Answers to Questions regarding to FCC inquiry 43739

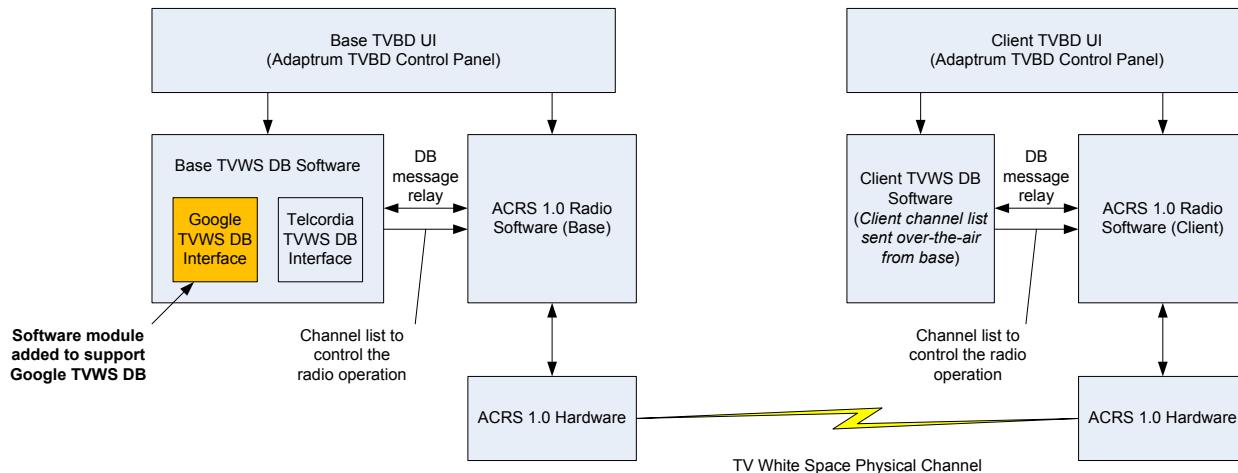
- 3. An installation manual and a user manual are not sufficient to support this Permissive Change application. Please provide a detailed list of what hardware and software changes have resulted from adding a database. This information would allow us to independently assess the possibility of any potential changes in reported RF and database interface performance. In the meantime, it is the applicant's responsibility to present supporting reasoning and test data to show that compliance is maintained. Please present your case against the applicable items listed in KDB 416721. Note that even the RF characteristics can be shown to be the same test results for the database interface requirements (15.713, 15.711, 15.707, 15.712, 15.709, and 15.715) should be presented**

A software module "Google TVWS DB Interface" is added to the base "TVWS DB Software" to support the Google TVWS Database as shown in the above figure. *Other software modules are not changed.* The added software module "Google TVWS DB Interface" allows the base software to register and retrieve channel lists from the Google TVWS Database for *both the base and the client*. The base channel list is

used to control the base radio operation as illustrated above. The client channel list is sent over-the-air to the client (on the base operating channel) and is used to control the client radio operation.

In the past certification of ACRS 1.0 system, the radio operation is controlled based on the channel list retrieved from Telcordia TVWS Database. In the new implementation, the radio operation is controlled based on the channel list retrieved from Google TVWS Database. However, the radio operation itself has not been changed. Please refer to the document "Test Procedures for Joint Certification of Google TVWS Database and Adaptrum ACRS 1.0 Fixed TV Band Device" for detailed compliance testing for the listed database interface requirements per KDB 416721.
